## 7.0 Instrumentation and Control Systems

### 7.1 Introduction

The information in this section of the reference ABWR DCD, including all subsections and tables, and figures, is incorporated by reference with the following departures and supplements.

Figure 7.1-1 ~~SSLC Self-Test System~~ Diagnosis

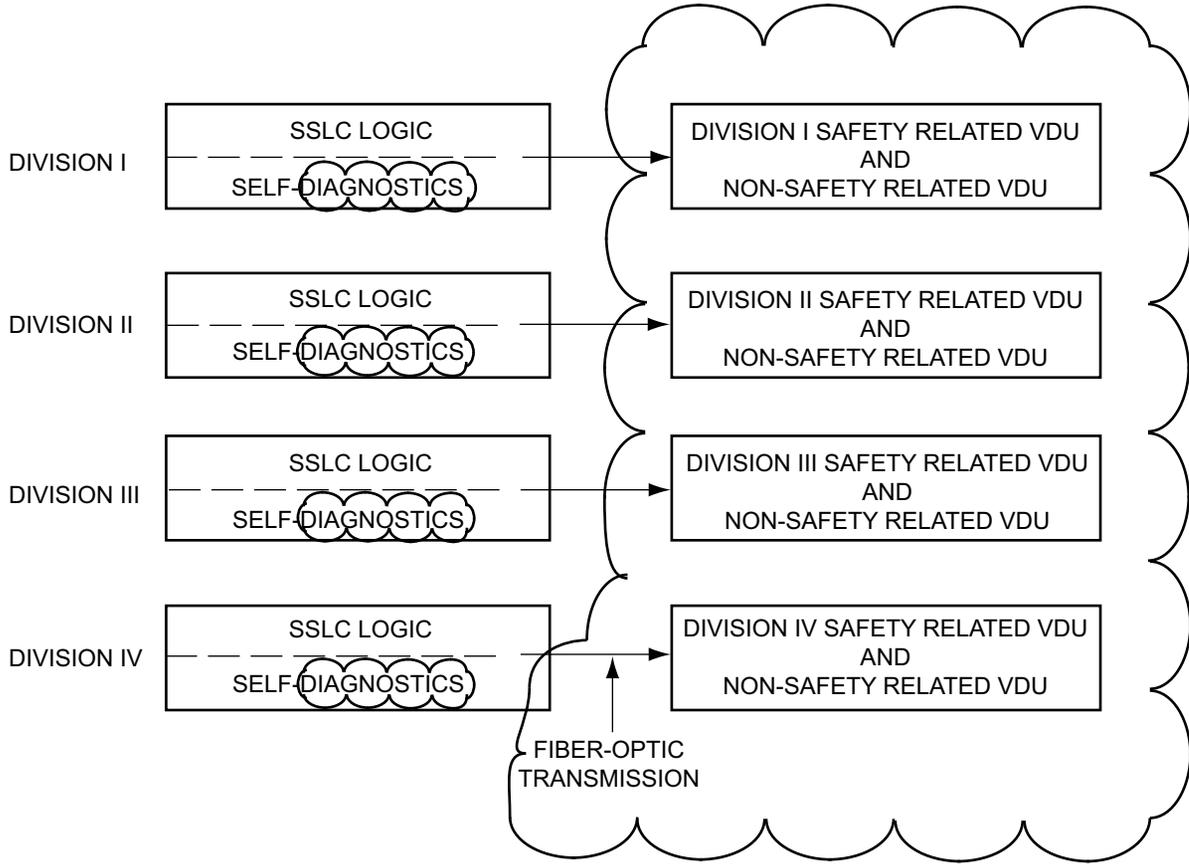
STD DEP T1 3.4-1 (Figure 7.1-1, 7.1-2)

STD DEP T1 3.4-1

*Each individual safety-related system utilizes redundant channels of safety-related instruments for initiating safety action. The automatic decision making and trip logic functions associated with the safety action of several safety-related nuclear steam supply systems (NSSS) are accomplished by ~~a four-division correlated and separated protection logic complex called the safety system logic and control (SSLC)~~. The SSLC includes multiple redundant divisions, which are separated from each other. The SSLC has four redundant divisions of sensors. Each division of sensors has a corresponding division that determines the trip status of the safety functions relative to the safety function setpoint. The SSLC has four redundant divisions for all actuation functions except for the engineered safety features. The engineered safety features have three divisions, corresponding to the maximum redundancy of the engineered safety features actuated components. Some engineered safety features functions are less than three-fold redundant and are assigned to the appropriate set of redundant divisions. The SSLC multi-divisional complex includes divisionally separate control room and other panels which house the SSLC equipment for controlling the various safety function actuation devices. The SSLC receives input signals from the redundant*

Figure 7.1-2 Assignment of Interfacing Safety System Logic to SSLC Controllers

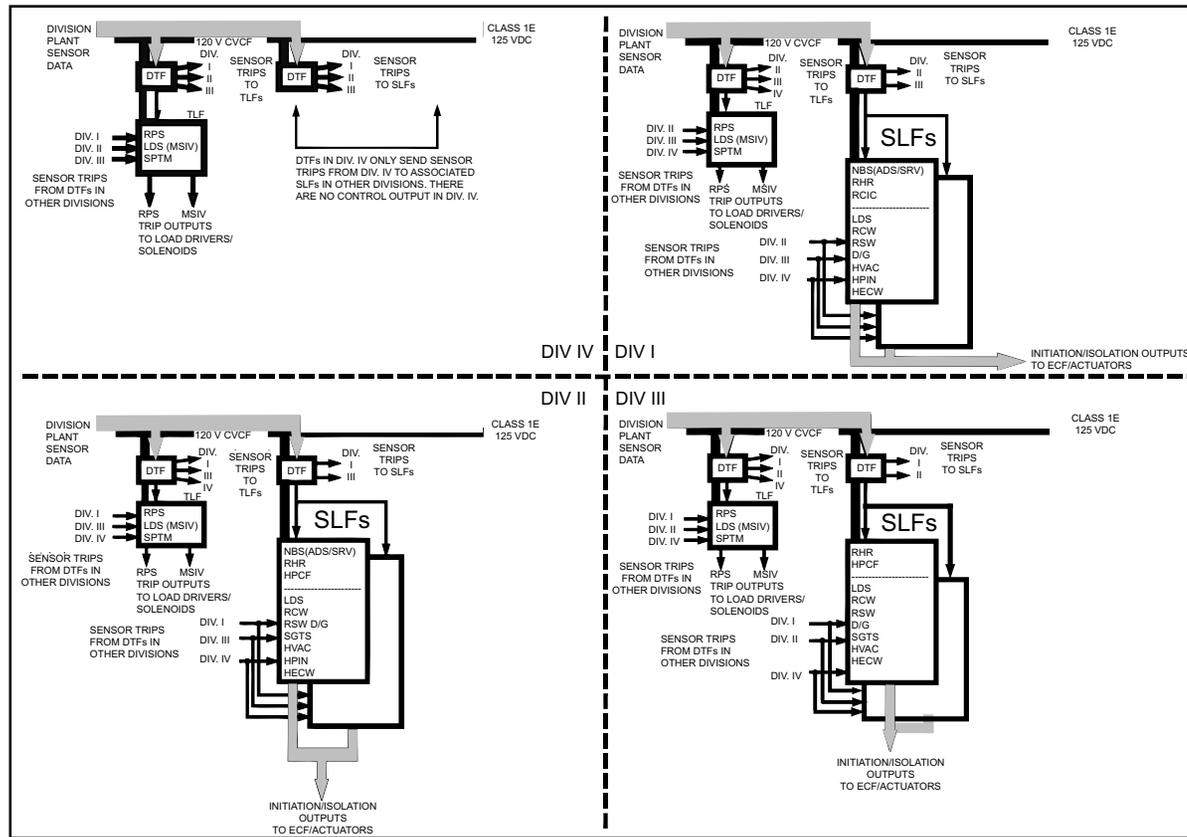
~~Divisional separation is also applied to the essential multiplexing system (EMS), which provides data highways for the sensor input to the logic units and for the logic output to the system actuators (actuated devices such as pump motors and motor-operated valves). Systems which utilize the SSLC are include: (1) Reactor Protection (trip) System; (2) High Pressure Core Flooder System; (3) Residual Heat Removal System; (4) Automatic Depressurization System; (5) Leak Detection and Isolation System; (6) Suppression ~~Temperature~~-Pool Temperature Monitoring System; and (7) Reactor Core Isolation Cooling System. The equipment arrangement for these systems and other supporting systems is shown in Figure 7.1-2.~~
